NORTH SYDNEY COUNCIL REPORTS

NSLPP MEETING HELD ON 02/02/22 SECTION 4.55 APPLICATION REPORT

ADDRESS/WARD: 51 Alexander Street, Crows Nest (W)

APPLICATION No: DA 473/15/2

Figure 5: Approved ground floor plan detailing approved retail tenancy layout, lift lobby and residential plant rooms.

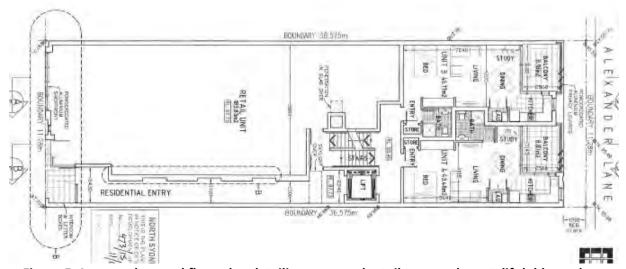
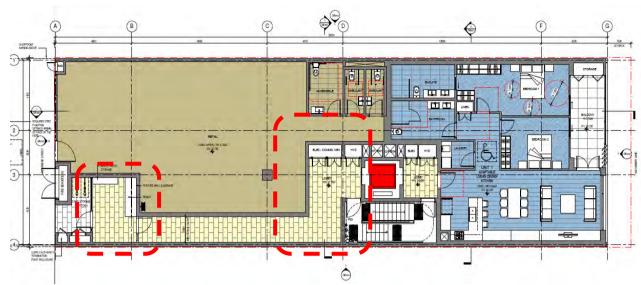
With the proposed amendments, including relocation of former plant areas located within the former basement area the practical area of the commercial tenancy on the ground floor is reduced to an effective area of 151 m^2 or Non residential FSR of 0.37 : 1 and represents a 26.7% variation. The variation is indicated in figures 5 & 6 below

Figure 6: Proposed amended commercial floor space showing residential plant room and ground floor lift lobby areas not included in original approved ground floor plan.

The proposed commercial tenancy will provide a non-residential floor space ratio that, despite non-compliance with the applicable numerical controls, achieves the objectives of Clause 4.4A. Compliance is considered to be unreasonable in the circumstances Given that it also maintains consistency with the objectives of the zone, its approval will be in the public interest and is supported in this regard.
